ADDENDUM COUNCIL ASSESSMENT REPORT

SYDNEY EASTERN CITY PLANNING PANEL

PANEL REFERENCE & DA NUMBER	PPSSEC-238 – DA-483/2022
PROPOSAL	Construction of three buildings ranging in height between 5 and 7 storey containing a mixed use industrial, warehouse and recreational development with 2 basement levels for parking, storage and plant areas (Water NSW & Integrated Development).
ADDRESS	Lot 2 DP 261143, Lot 1 DP 219847, Lot 3 DP 271143 2-6 Girawah Place, Matraville
APPLICANT	Mr Agy Dassakis, Spirecorp Pty Ltd
OWNER	Spirecorp Pty Ltd
DA LODGEMENT DATE	4 October 2022
APPLICATION TYPE	Development Application
REGIONALLY SIGNIFICANT CRITERIA	Clause 2, Schedule 6 of <i>State Environmental Planning Policy (Planning Systems) 2021</i> : Development that has a capital investment value of more than \$30 million.
CIV	\$37,802,636 (excluding GST)
CLAUSE 4.6 REQUESTS	None
KEY SEPP/LEP	Transport and Infrastructure SEPP, Biodiversity and Conservation SEPP, Resilience and Hazards SEPP Randwick LEP

<ul style="list-style-type: none"> • Plan of Management (King Beats Fitness) • Gym Floor Plan Layout • Bunnerong Creek Plans • Waste Management Plan • Response Letter to Traffic Issues • Industrial Market C

Figure 2: Basement 2 Plan (Source: Drawing No. DA_101 – Bennet Murada Architects)

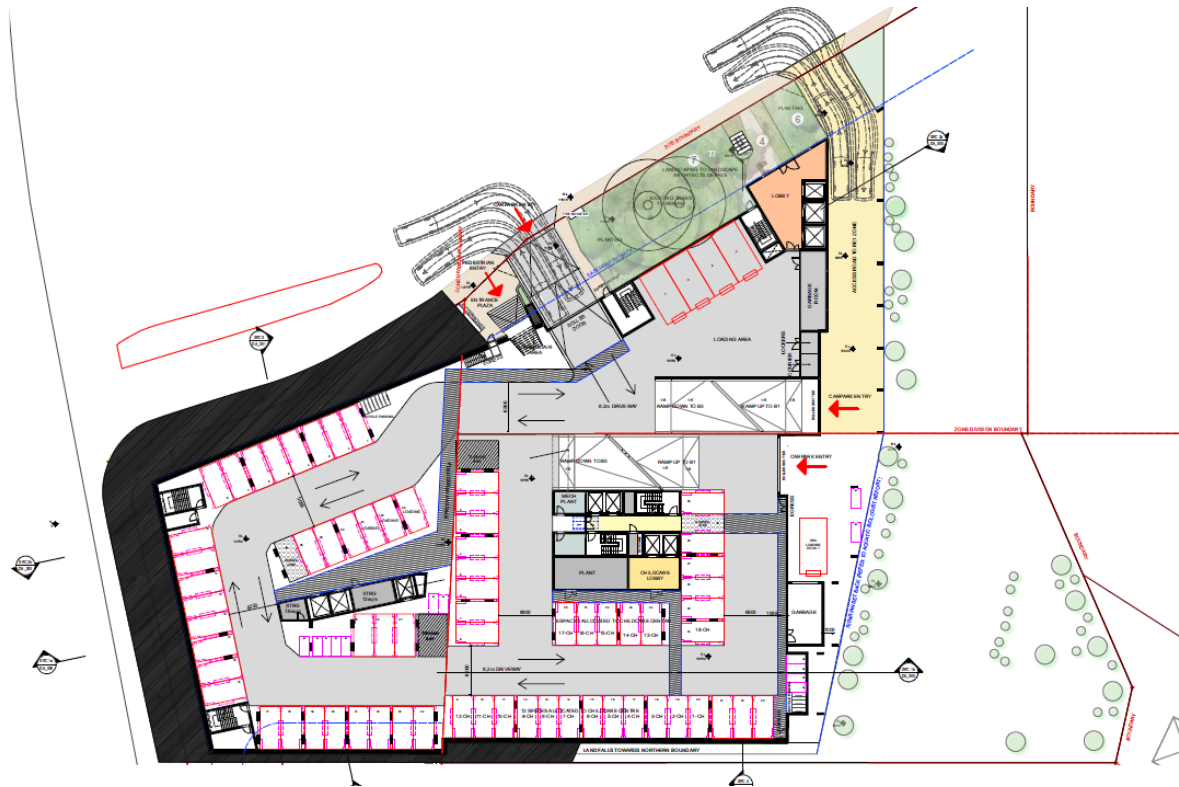
In the above layout, there is no physical separation proposed between the parking areas on the IN1 and RE2 zoned land. To ensure permissibility is fully satisfied, a condition of consent is recommended to erect a fence on the zone and lot boundaries to separate the industrial and recreation car parking areas. This condition can be achieved without compromising access, turning circles and compliance with applicable standards under AS2890.2 as the plans have accommodated suitable turning bays and clearance adjacent to the spaces.

Amended plans have been submitted that have separated the basement by their land zoning. The amended Basement 2 Plan is illustrated in Figure 2 whereby the IN1 and RE2 zoned land are capable of operating independently. Separate building entries and exits, loading bays, waste areas and lobbies are all proposed that are contained within their respective zonings.

Figure 3: Site Context Sections (Source: Drawing No. DA_153 – Bennett Murada Architects)

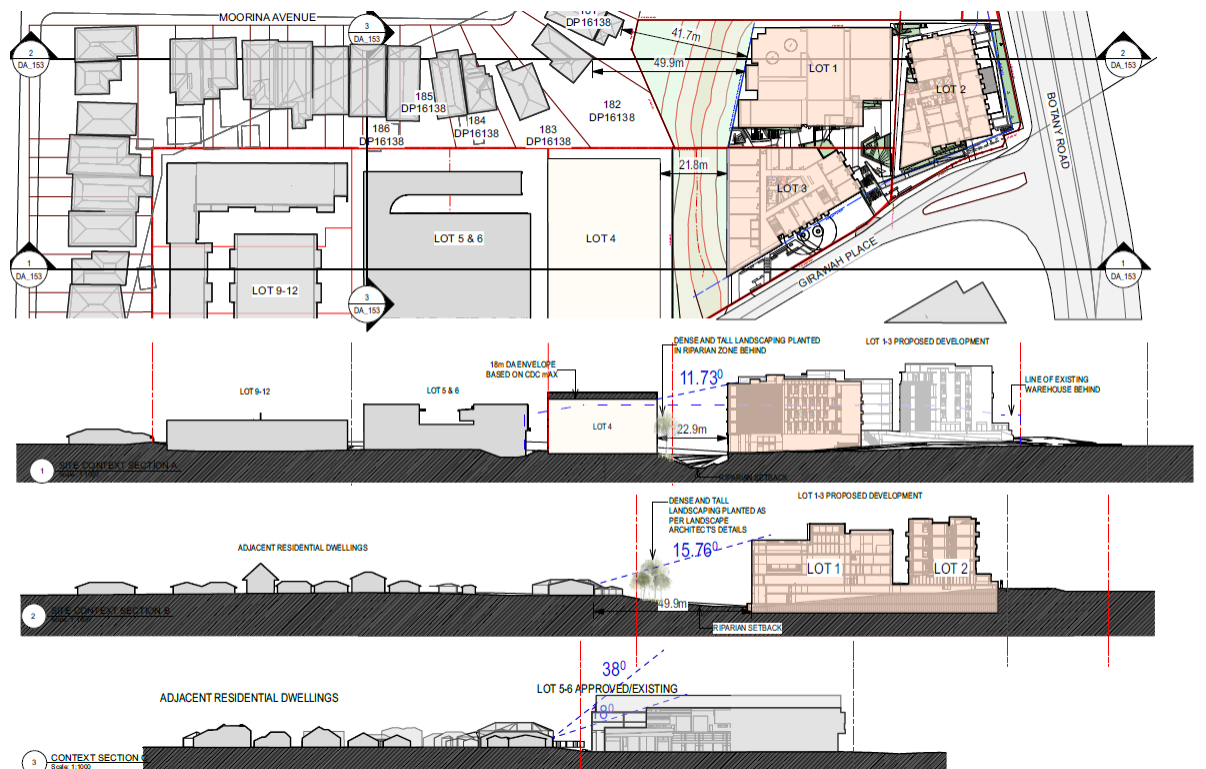
Of note, the separation distances approved on Lots 5-6 and 9-12 identified in the site context sections are substantially less than what has been proposed for Lots 1 and 3. It is noted these buildings are of a far lesser height than the proposed buildings.

Figure 4: Level 3 Plan Extract (Source: Drawing No. DA_106 – Bennett Murada Architects)

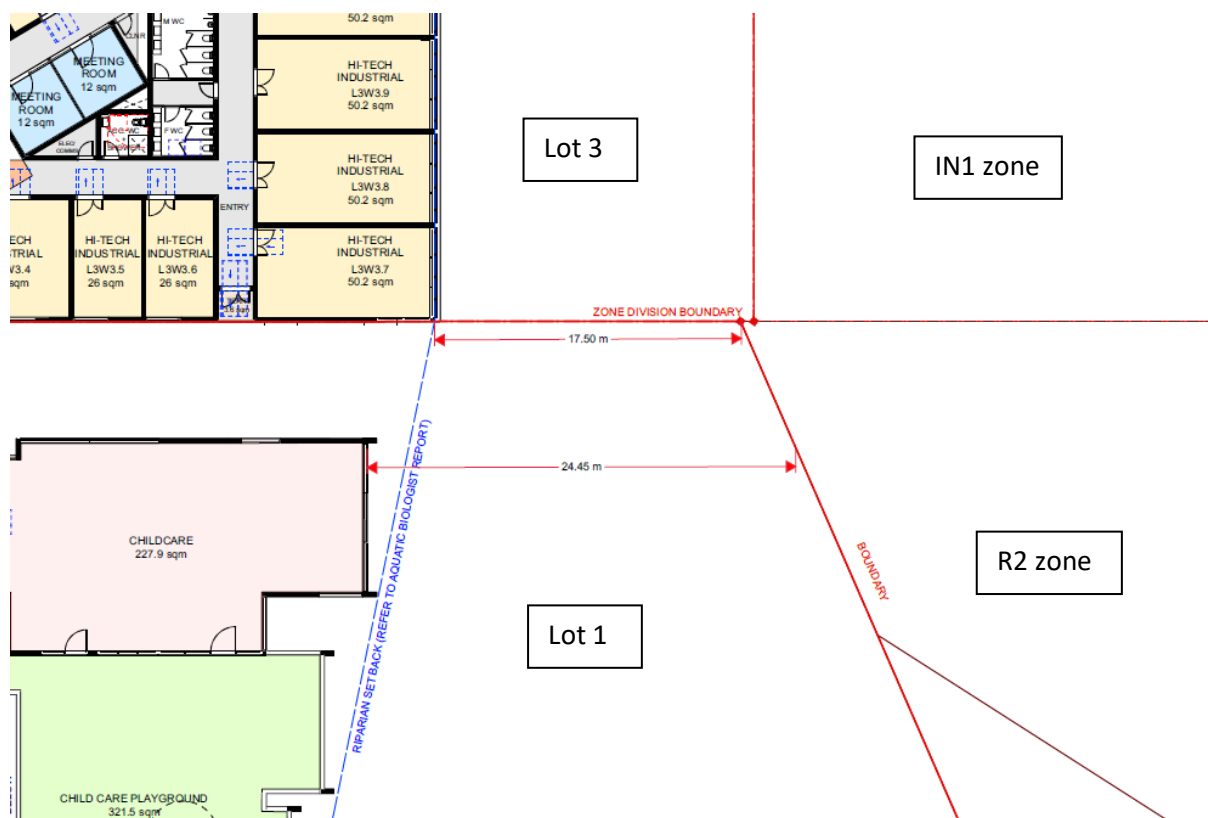
- The height of the building on Lot 3 is approximately 23.6m at the northern elevation and has a minimum setback of 17.5m to a residential boundary.
- The height of the building on Lot 1 is approximately 21.9m at the northern elevation and has a setback of 24.4m.

The interface between the building on Lot 3 and the residential zone is largely diagonal, with only a fraction of the built form directly interfacing with the R2 zone. Refer to Figure 4 below. The extent of the building within the implied appropriate separation distance under the CDC assessment is limited and all windows achieve only diagonal views toward the R2 zone. The principal outlook is directly over the riparian land to Lot 4, a vacant industrial zoned land parcel, which requires no setback. The land is to the southwest of the residential zone and no overshadowing occurs. Given no notable visual privacy impact and no overshadowing impact, the setback and separation of the building on Lot 3 are deemed acceptable.

Figure 5: Previous Ground Floor Plan (Source: Drawing No. DA_102 – Bennett Murada Architects)

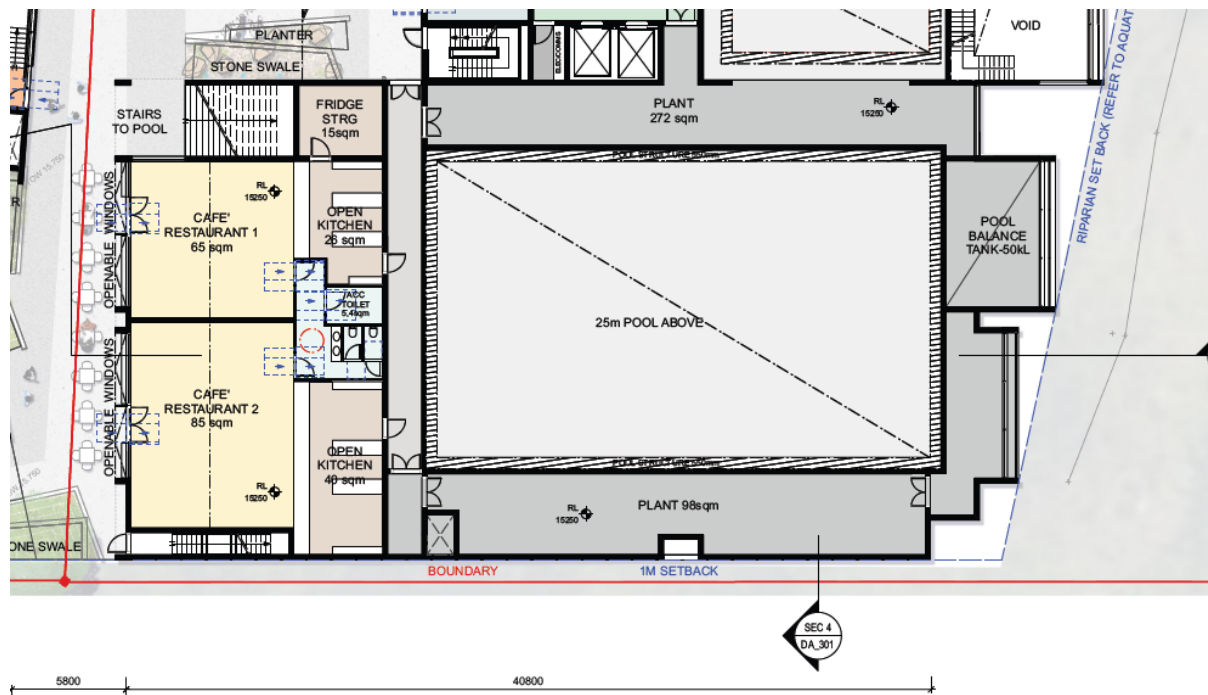
The eastern adjoining property of the building on Lot 1 is the Council owned RE1 Public Recreation zoned land. The previous proposal provided a primarily 1m setback to the eastern boundary for the full length. This is illustrated in the Ground Floor Plan extract below.

Following further discussions with the applicant, the amended package submitted with the application increased the setback to 2.4m. Refer to the amended Ground Floor Plan below.

Figure 7: Lot 1 and Lot 2 Setback Diagram (Source: Drawing No. DA_154 – Bennett Murada Architects)

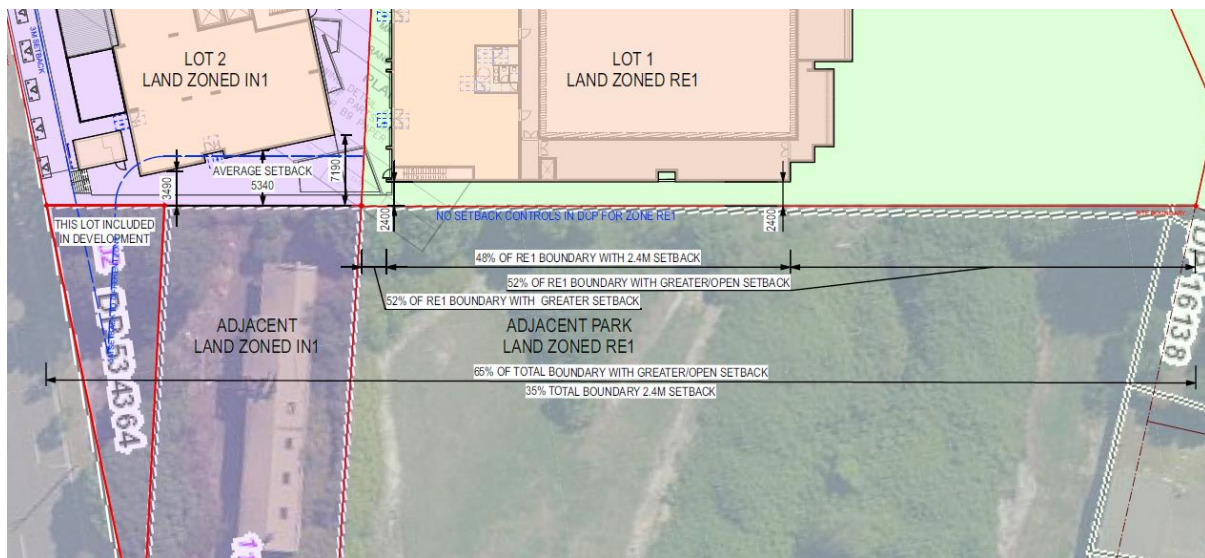
The DCP does not contain any setback controls that apply to the RE2 zone. In place of any prescribed controls, the CDC controls are again drawn as a reference point for the merit assessment of the setbacks given the industrial context of adjoining land. CDC permits an 18m tall building with a 3m setback to a public reserve under Section 5A.11. A 3m setback would then be of similar level appropriateness for the proposed development up to 18m in height.

The proposed 2.4m setback is less than what is permitted under CDC on industrial land. However, the 600mm shortfall is deemed inconsequential from a visual impact perspective and is considered generally acceptable for the portion of the building that is below 18m in height.

However, as the building exceeds 25m in height on the east elevation, the remaining portion of the building is subject to further scrutiny on the appropriateness of the setback and the appearance of the elevation.

Figure 9: Current Proposed 3D View of the East Elevation of Lot 1 (Source: Drawing No. DA_160 – Bennett Murada Architects)

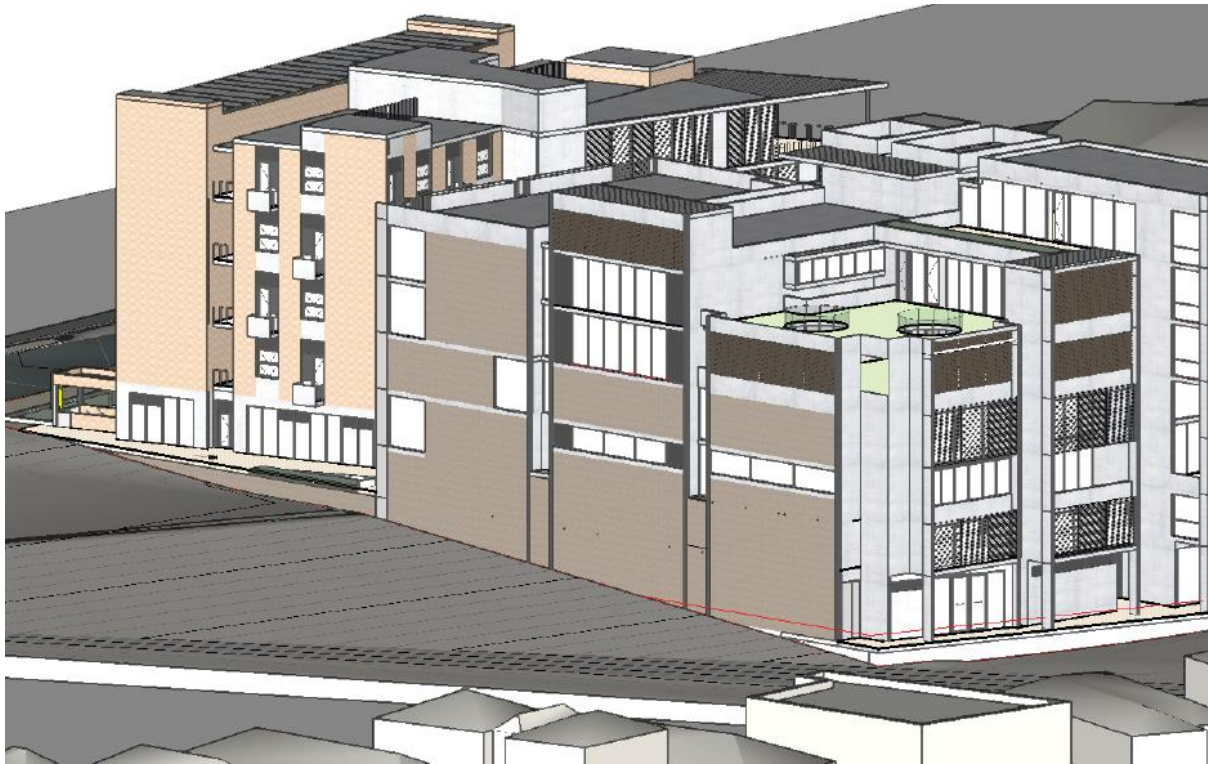
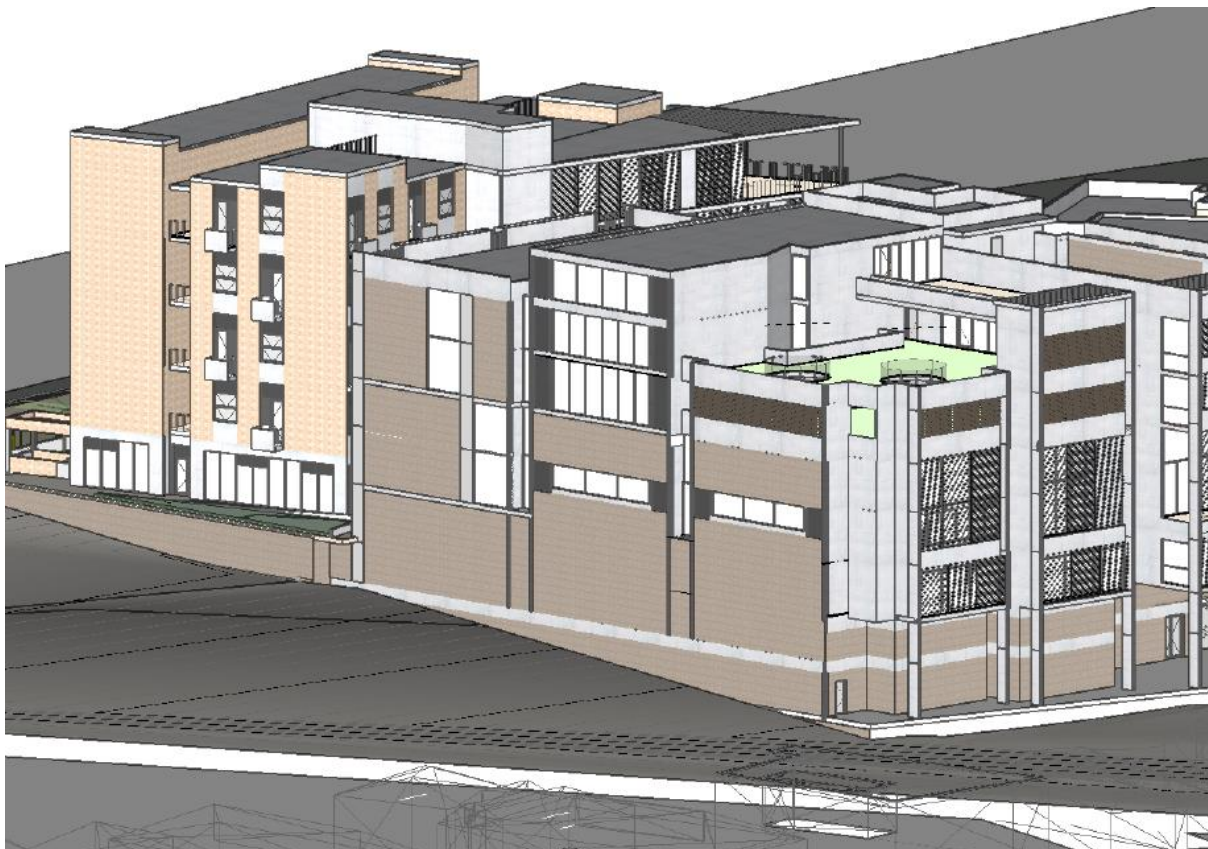
In terms of the appearance of the eastern elevation, it is first acknowledged the proposal has been amended through the supplementary assessment process. The two figures on the following page illustrate the previous and current proposed east elevation of the building on Lot 1. The two points of difference are the addition of an extra portion of glazing on the top level associated with the unspecified indoor recreation facility and a consolidation of windows on the southern portion of the elevation, though no increase in total glazing.

While Council has no specific plans in place as to the future of the RE1 Public Recreation land, consideration must still be given to the potential of the land and the interface of the development to it. A building exceeding 25m in height with a 2.4m setback is deemed excessive as the limited setback is not sufficient to achieve any significant tree planting to soften the interface and, similar to the previous 1m setback proposal, continues to rely on the public land to mitigate the scale of the building.

It was discussed with the applicant that if an insufficient setback would be provided for suitably scaled landscaping compatible with the height of the building, an alternate option is for a high level of activation between the eastern elevation and the public land. Activation is highly encouraged between private development and public spaces to satisfy the principles of casual surveillance and reduce visual impacts. The introduction of additional glazing is supported; however, the elevation remains secondary in the level of activation, particularly on the lower levels.

Options were discussed with the applicant to increase the activation of the public land. These included additional glazing on the lower levels, particularly for the aquatic centre level through relocating the seating positioned on the eastern wall and the introduction of full height glazing, and for the gym by increasing the height and extent of glazing. These were not adopted.

Figure 11: Lot 1 Level 3 Floor Plan (Source: Drawing No. DA_106 – Bennett Murada Architects)

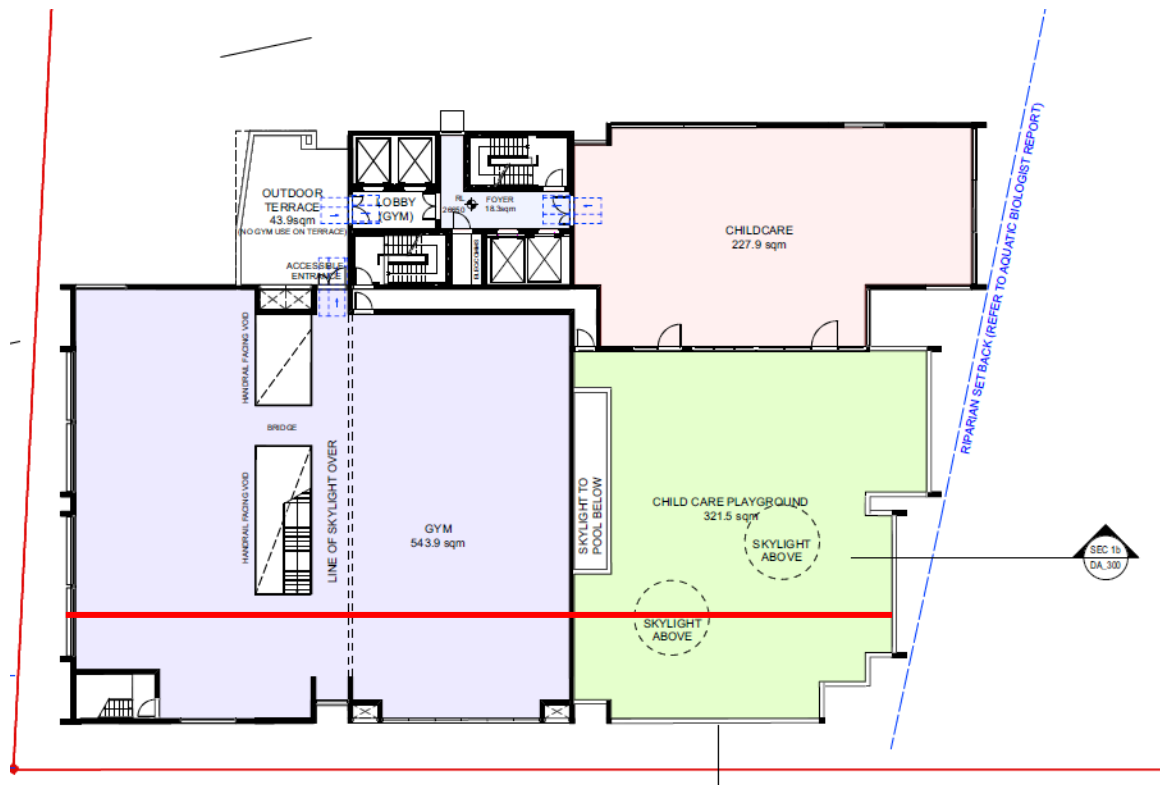
In effect, this will necessitate a redesign for the gym, child care centre and Level 5 indoor recreation facility tenancy. Refer to the floor plans of Levels 3-5 below. The red line marks the approximate 8m setback.

The imposition of such a condition will require the relocation of floor area outside of the setback. For the gymnasium, the current top level (Level 3) proposes a 6.26m-6.3m floor to ceiling height. The creation of a new mezzanine on Level 4 would allow for the full retention of all floor area the gym currently seeks. The sizeable floor to ceiling height facilitates the provision of a mezzanine with sufficient floor to ceiling heights for the functionality of a gym.

It is recommended that a minimum setback of 8m is to be created from the eastern boundary on Levels 3 and above of the building on Lot 1.

Figure 12: Lot 1 Level 4 Floor Plan (Source: Drawing No. DA_107 – Bennett Murada Architects)

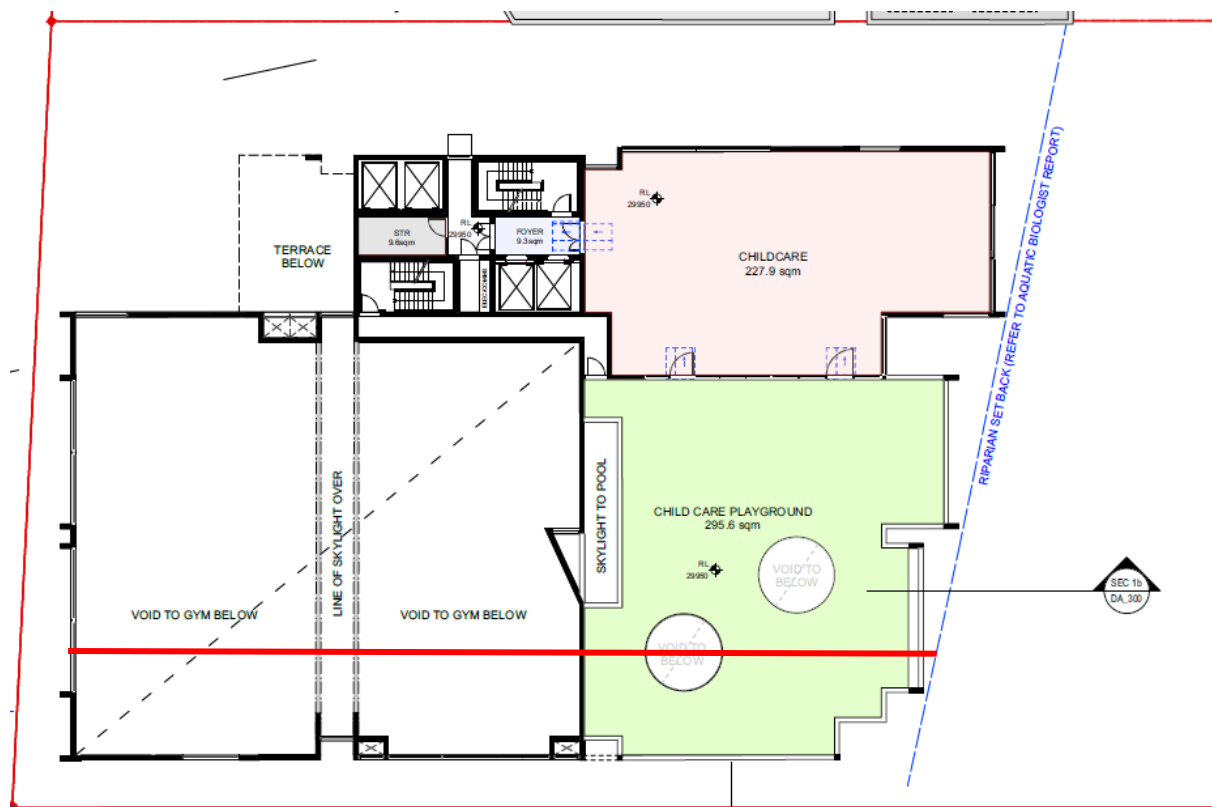
The child care centre over Levels 3 and 4 may reconfigure the outdoor play area to utilise part of the void over the gym to maintain the current size. The internal area is unaffected.

Figure 13: Lot 1 Level 5 Floor Plan (Source: Drawing No. DA_108 – Bennett Murada Architects)

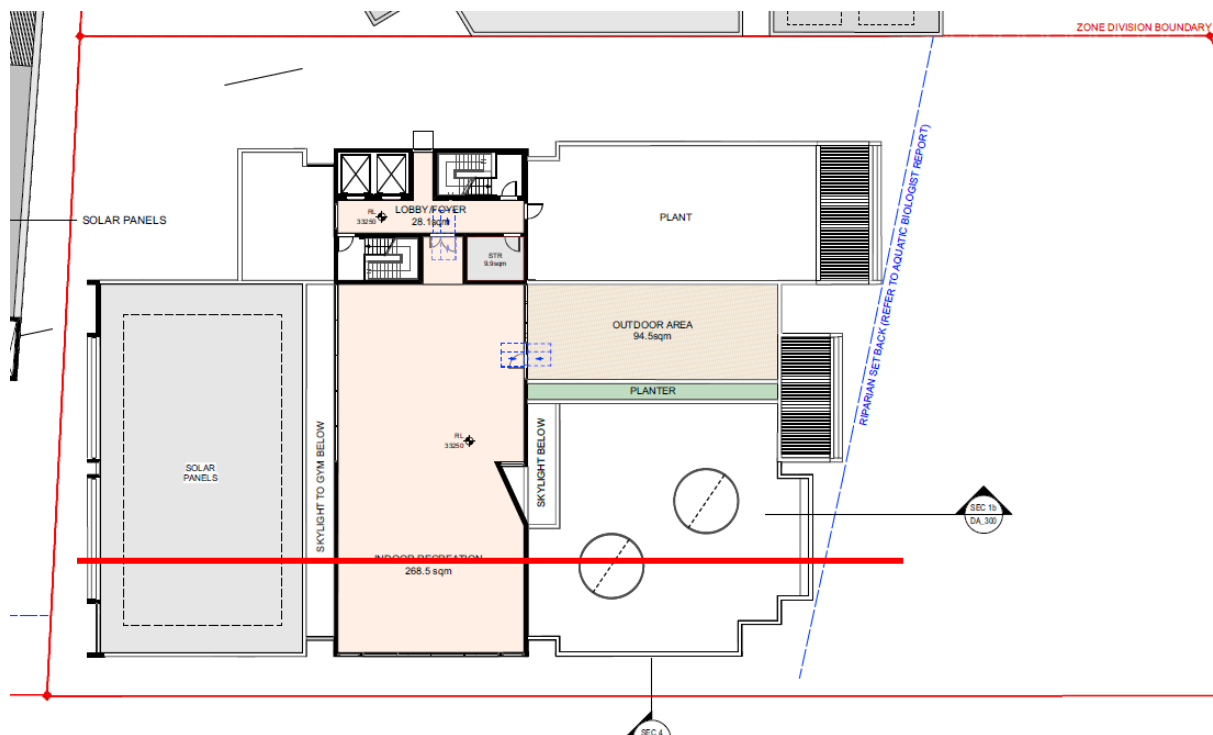
For the Level 5 indoor recreation tenancy, the floor area within 8m of the boundary can be relocated to the southern side of the tenancy in the area identified for solar panels.
